U.S. Department
of Transportation
**Federal Highway
Administration**

In Reply Refer To: HSA-10/WZ-200

Thank you for your letter of January 28, 2005, requesting Federal Highway Administration (FHWA) acceptance of your company's MB-42 x 45 high-density polyethylene (HDPE) units as crashworthy traffic control devices for use in work zones on the National Highway System (NHS). Accompanying your letter were drawings of both the original and newly designed units and material specifications for them. You requested that we find the new devices acceptable by virtue of their similarity to the original units you had tested under the provisions of National Cooperative Highway Research Program (NCHRP) Report 350 "Recommended Procedures for the Safety Performance Evaluation of Highway Features." You asked that they be accepted as a Longitudinal Channelizing Barricade at test level 1 (TL-1) when linked together and as TL-3 Manual Uniform Traffic Control Devices Type II Barricades when they stand alone. You also followed up with additional information on March 10, 2005.

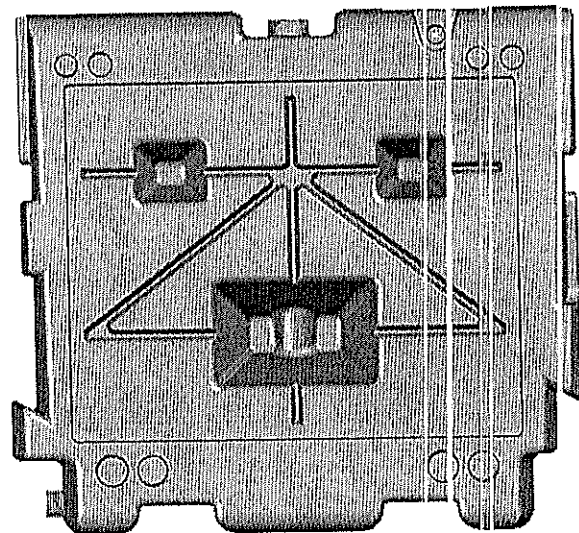
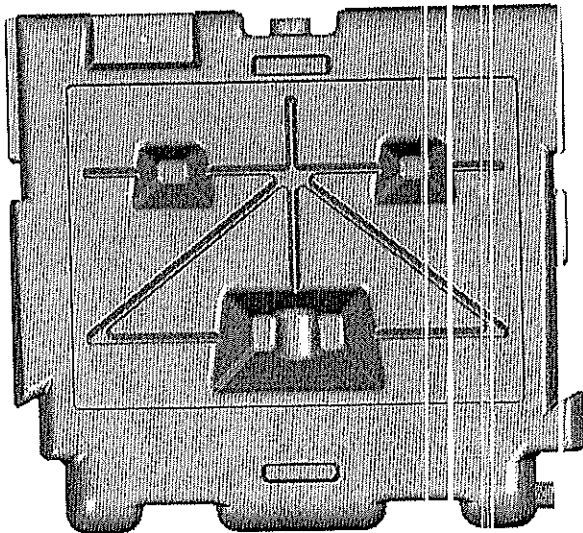
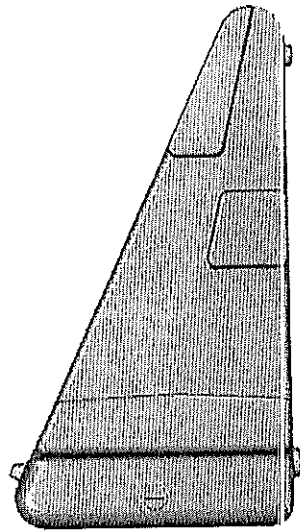
The new MB-42 x 45 HDPE units are blow molded with HDPE and measure 40 inches long and 48 inches tall. Each section is 22.5 inches wide at the base, tapering on one side to a top width of 5 inches. The wall thickness is 0.156 inches and a single unit weighs 35 pounds when empty. The new units are 6 inches lower, 5 inches longer, and 15 pounds lighter than the tested units. The maximum water ballast that they can hold is 721 pounds, or 200 pounds less than the crash tested version. Because the tensile strength of the HDPE is significantly greater than that of the low density material, the wall thickness can be reduced using the HDPE and still maintain the strength of the units similar to the LLDPE crash-tested units.

The change in fabrication from a roto-molded product using low-density polyethylene (MB-48 x 40) to a blow-molded product using high-density polyethylene (MB-42 x 45) may affect the performance of the devices. The thinner HDPE walls of the new units are roughly 20 percent stronger than the thicker LLDPE walls in the tested units. You have arranged to have a TL-3 test (NCHRP Report 350 Test 3-10) conducted on the MD-42 x 45 HDPE LCB to assess the high-speed performance of the new units. Assuming the test is successful, you asked that the FHWA consider this test as sufficient to judge the TL-3 performance of the original MB-48 x 40 also. We agree in principal to this request, but reserve final judgment pending our analysis of the crash documentation to verify that performance will be comparable.

Based on the analysis above we concur that the new MB-42 x 45 HDPE units will be acceptable as TL-3 stand-alone Type II barricades and as a TL-1 LCB for use on the NHS under the range of condition that the MB-48 x 40 was tested, when proposed by a State.
